# TECHNICAL NOTE

| Project     | Site A Willow Way, Sydenham                  |                           | Project No. | 22/089  |             |
| Subject     | Technical Note in Support of Planning Appeal |                           | Document No | TN004   |             |

**Table 1-1: LBL Officer Report Comments on the Application and VTP Response**

FOOTWAY WIDTH MEASUREMENTS

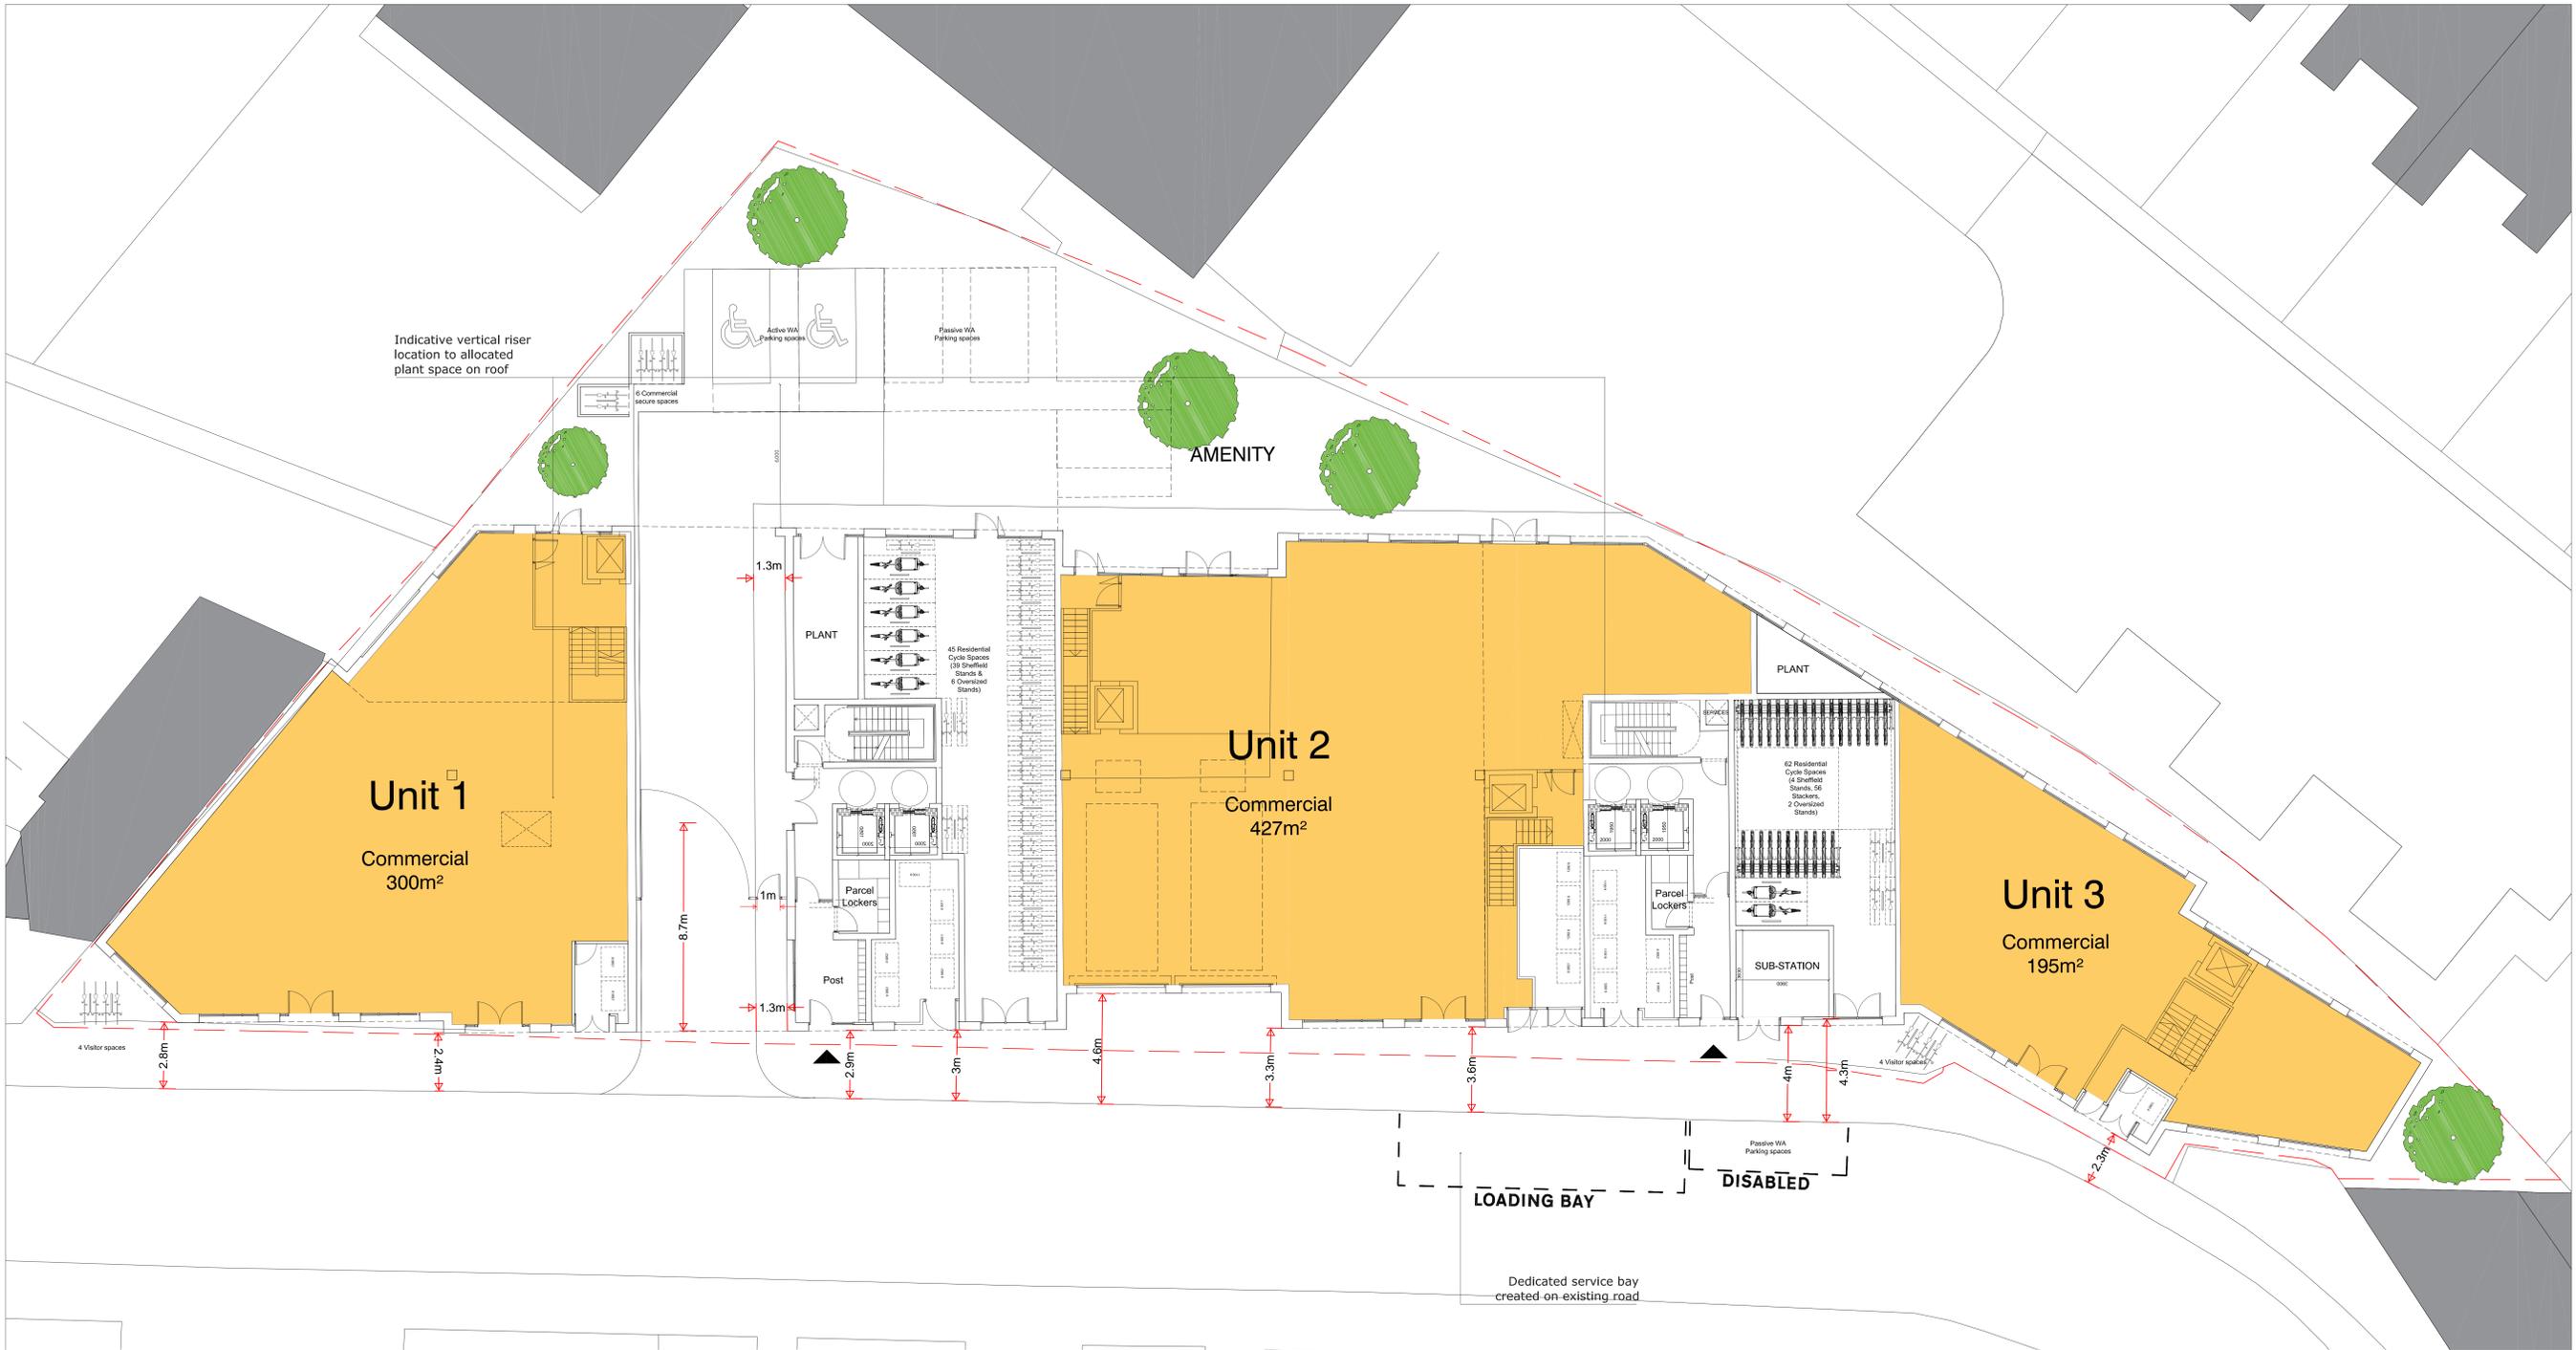
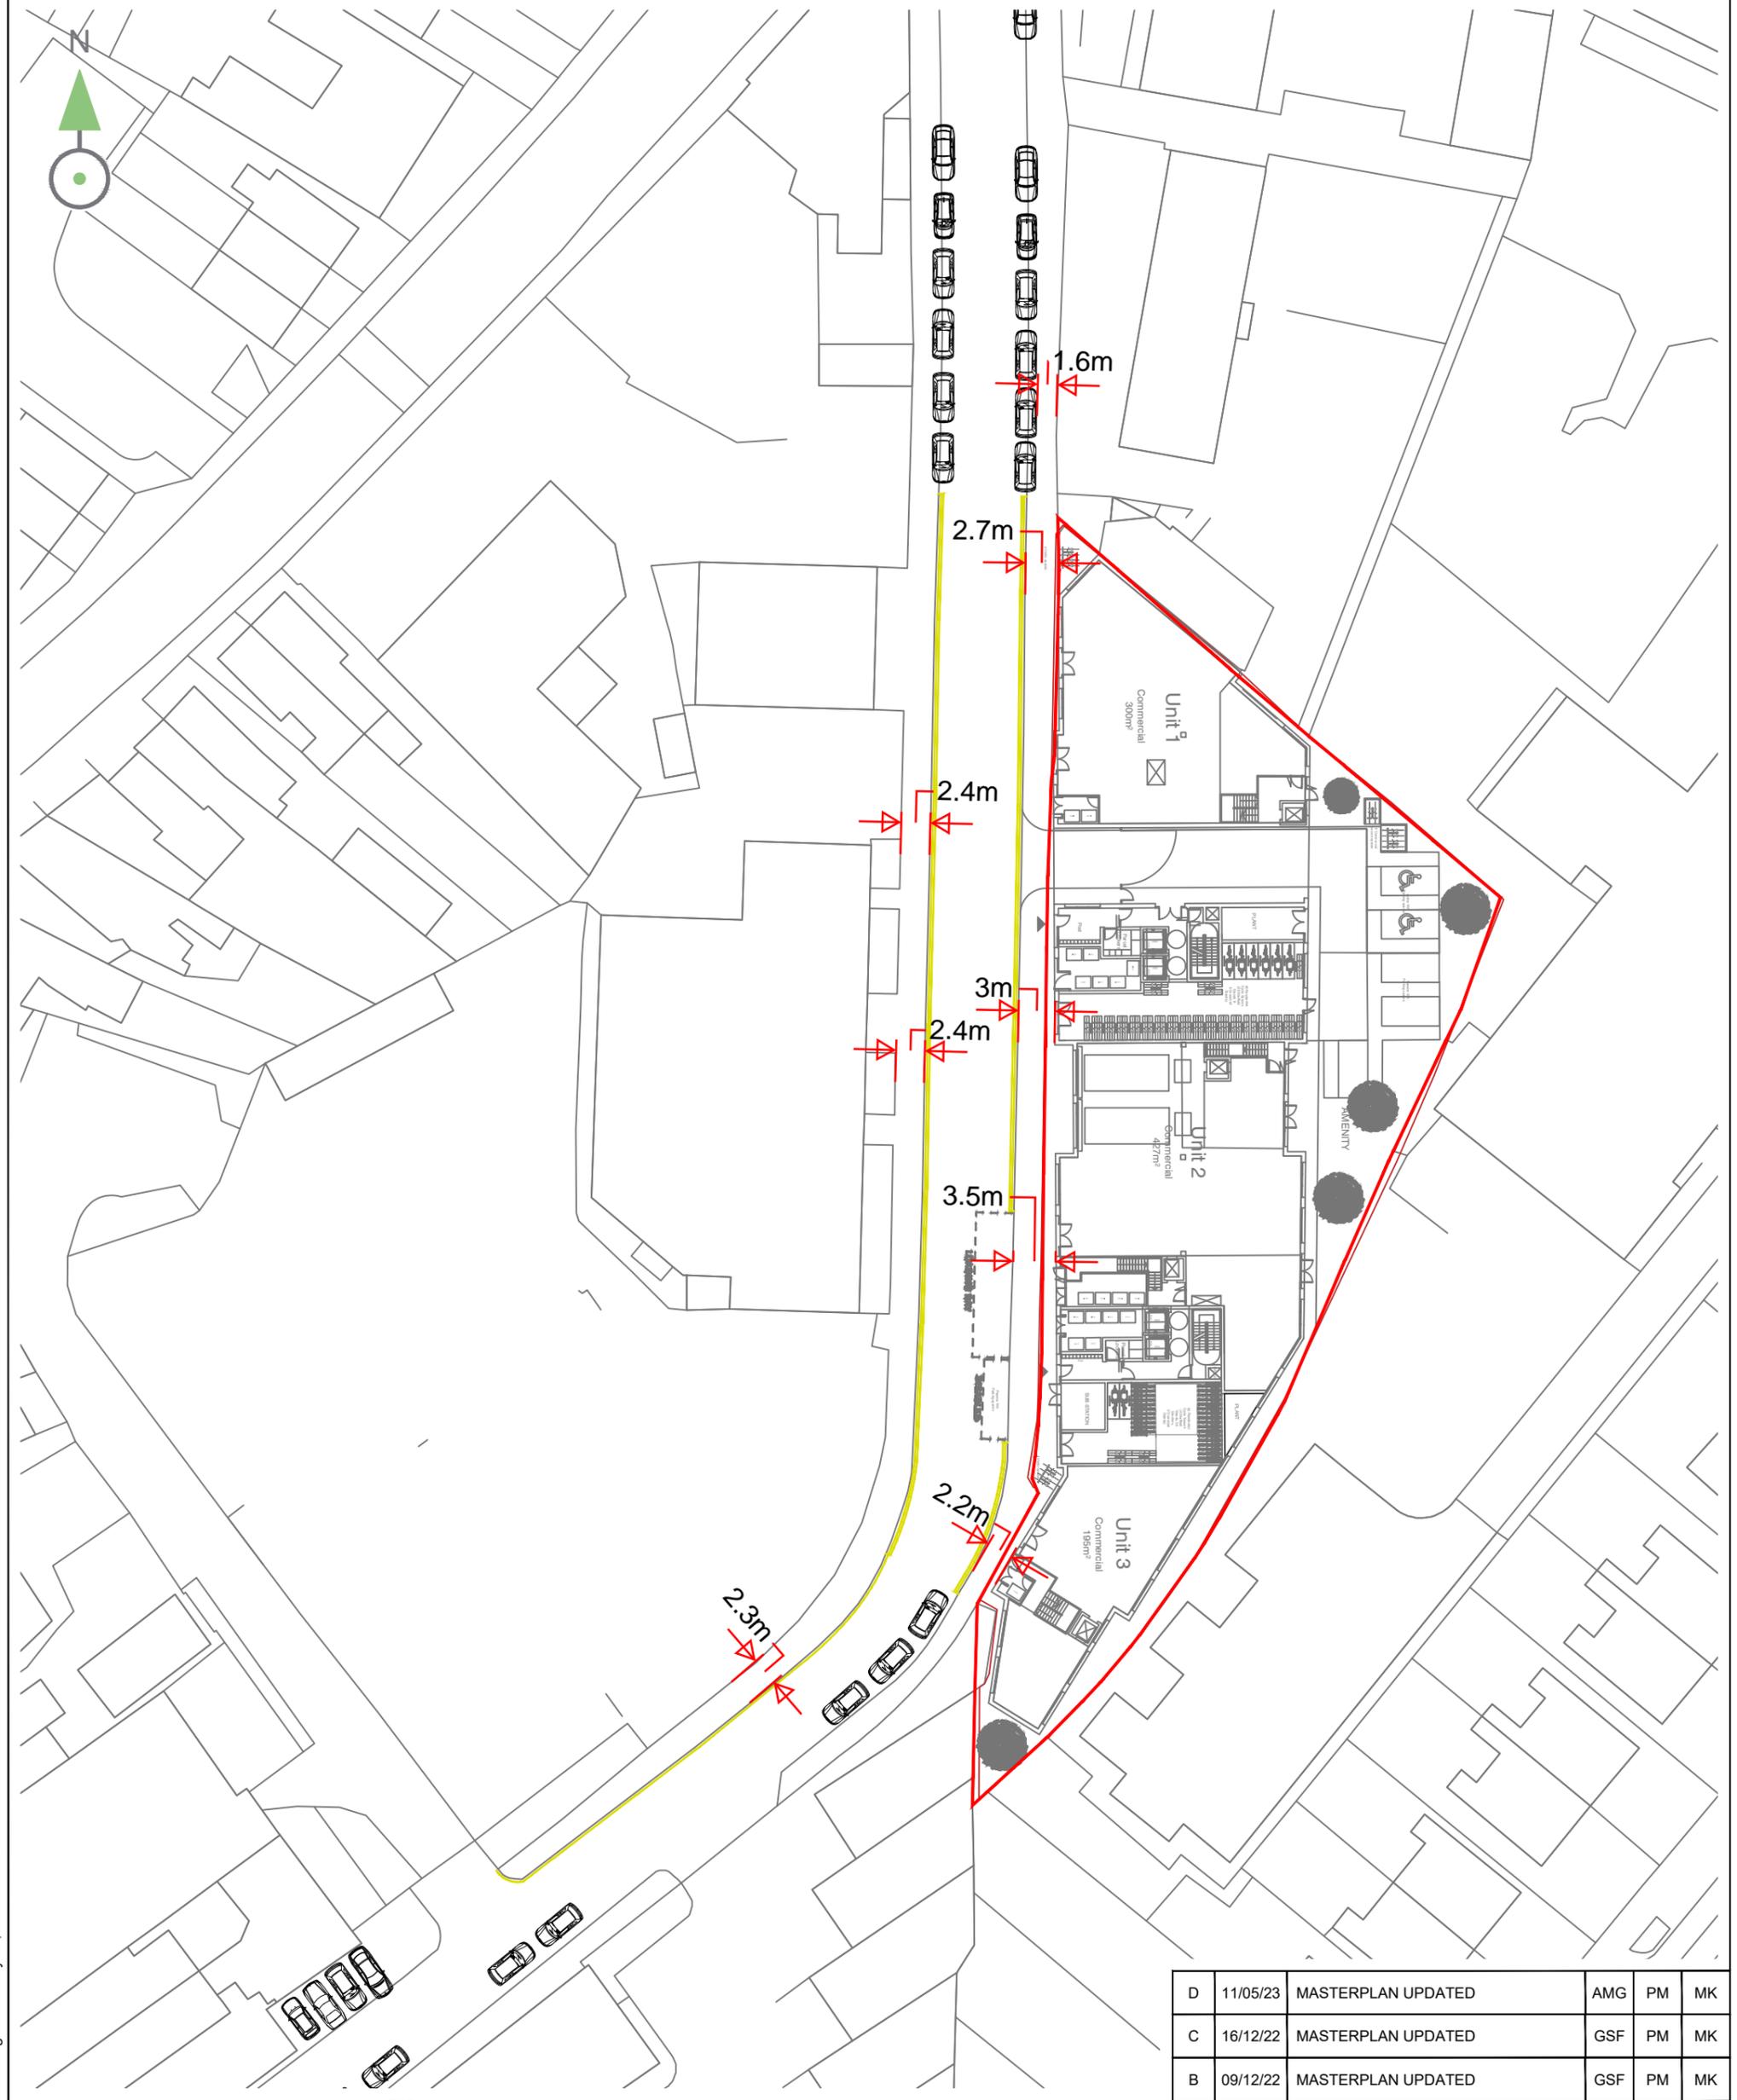
| PARAGRAPH | PLANNING OFFICER / LBL HIGHWAYS COMMENT   | VTP RESPONSE   |
|-----------|---|--|
| 288       | <p><b>Footway Widths:</b><br/>Willow Way is subject to narrow footways on both sides of the carriageway. As part of this application the proposed ground floor plan shows a general footway width of 2.5 to 2.8m along the site frontage. However with the mounted kerbside parking this width would be reduced. The applicant will need to provide an assessment of how much effective footway width there will be for pedestrians with parked cars. The introduction of 60 residential units at a car free site indicates that there will be a high percentage of occupants travelling by foot, cycles and via public transport. The TA at paragraph 5.3.12 indicates that there will be a peak of 58 people trips in the AM period as a result of the proposed development. The existing footways along the front of the site would benefit from widening to accommodate the new development.</p> <p>It is noted that the LBL Highways consultation response also states that the "The width of the access is considered acceptable however the 1.2m footpath should be a minimum of 1.5m to allow for a pedestrian and a wheelchair user or pedestrian with a buggy to pass each other in accordance with TfL's Streetscape Guidance and in accordance with DfT's inclusive mobility guidance."</p> | <p><b>On-site Footway</b><br/>The proposed footway alongside the vehicular access to the rear parking court measures 1.3m in width which is considered to be suitable due to the nature of the footpath (in a quiet, low traffic location), the footfall expected, and the length of footway required to be traversed for most journeys, which is 8.7m from the site boundary to the double door entrance leading to the access core for the Unit 2 residential floors as shown below:</p> |

| PARAGRAPH | PLANNING OFFICER / LBL HIGHWAYS COMMENT | VTP RESPONSE   |
|-----------|---|--|
|           |   | <p>This footway could be provided flush to the carriageway (with a footway delineated using paint or blockwork) to significantly increase the effective width. Aside from this, TfL's Streetscape Guidance notes that footway clear zones such as the footpath in question have an acceptable minimum of 1.5m, or an absolute minimum of 1.0m (page 210). It is noted that the guidance also states that the maximum length of the restricted width footway should be 6.0m which is slightly exceeded in this instance. Given that this is a section of footway largely falling within a private development, which will be subject to low pedestrian flows, this is considered to be an acceptable arrangement.</p> <p>Importantly, page 210 also states that <i>“the width of the clear zone provided should relate directly to the character and use of the street, and in particular the volume of pedestrians. The footway clear zone should be designed to comfortably accommodate peak pedestrian demand and satisfy acceptable levels of service”</i>. As this footpath serves one unit only, which includes an entrance from the Willow Way frontage, the volume of pedestrians using the footpath is likely to be very low (circa 20-30 movements in the AM peak hour) and congestion is unlikely to occur.</p> <p>Figure 6.8 of Manual for Streets (page 68) also suggests a footway width of 1.2m is sufficient for an adult and child to walk two abreast, and 1.5m would allow two adults to walk together, as well as an adult and pram/wheelchair user. Given the nature of this footpath which is a route between a building entrance and the public highway, it is unlikely that pedestrians will be materially impacted by not being able to walk two abreast, and it is unlikely that a vehicle will use the access at the same time as they access/egress the site given the low number of disabled parking bays provided on-site.</p> <p>Pedestrians are therefore considered unlikely to be adversely impacted by this footway being 0.2m narrower than what is considered by LBL to be the acceptable minimum. See <b>APPENDIX A</b></p> <p><b><u>Willow Way Footway</u></b></p> <p>With regards to the Planning Officer's comment regarding the footway width along the site frontage on Willow Way, it is important to note that the application includes a proposal to provide double yellow lines on both sides of the carriageway. This will prohibit parking on-street and parking half-on the footway (as is currently observed by drivers). This will prevent the effective width of the footway from being reduced by</p> |

| PARAGRAPH | PLANNING OFFICER / LBL HIGHWAYS COMMENT  | VTP RESPONSE  |
|-----------|--|---|
|           |  | <p>kerbside vehicles, increasing it from around 1.5/1.6m of available width to a minimum of 2.2m of achievable width as shown in the plans in <b>Appendix A</b>. The typical footpath width along the site frontage will be around 3m which is a significant improvement on the existing situation.</p> <p>1.5m is also considered to be the minimum acceptable width for a footway clear zone as stated in TfL's Streetscape guidance, allowing for a wheelchair user and person walking to pass one another. Therefore, in the rare event that a vehicle driver fails to observe the proposed double yellow line restrictions, the footway width would remain of a width that is considered to be acceptable.</p> <p>It is therefore considered that the proposal will improve the effective footway width along Willow Way by addressing the issue of vehicles mounting the kerb, with a minimum width of 2.2m and a maximum of 3.5m along the site frontage. The proposed width will also be sufficient for the peak hour pedestrian demand associated with the proposed development. See <b>APPENDIX A</b></p> |
| 289-290   | <p><b>Masterplan:</b><br/>The applicant has submitted an emerging Masterplan document that shows significant changes to the public realm including a setback of the buildings on the opposite side of the road to create a 20m street width to allow for active travel, parking and servicing. The masterplan also shows a one-way vehicle restriction accompanied with a cycle contraflow lane. All of this is welcomed and would address the issues raised above.</p> <p>However no improvements specifically with regards to widening of the Willow Way highway footway have been proposed within the boundary of the current application. This is something that will need to be addressed in order for the application to be considered acceptable to Transport. Options like setting the building back to improve the existing footway for this application will need to be considered.</p> <p>Officer comment: for the application proposal to be acceptable, a wider footway would be required for usability and to avoid conflict of uses with increased residential trips, increased trips associated with the employment use, a new servicing bay as well as navigating the road as existing, congested</p> | <p>Consideration has been given to the adjacent plots and wider Masterplan during the design of the proposals for Site A. As noted above, the application includes a proposal to provide double yellow line restrictions on both sides of Willow Way which effectively widens the footway along the site frontage by preventing vehicles mounting the kerb and parking on-street. It is therefore considered that further alterations to the widths of the footways are not necessary. The public realm and environment for pedestrians will naturally be improved through the removal of on-street parking along Willow Way in accordance with Healthy Streets principals. See <b>APPENDIX A</b></p>   |
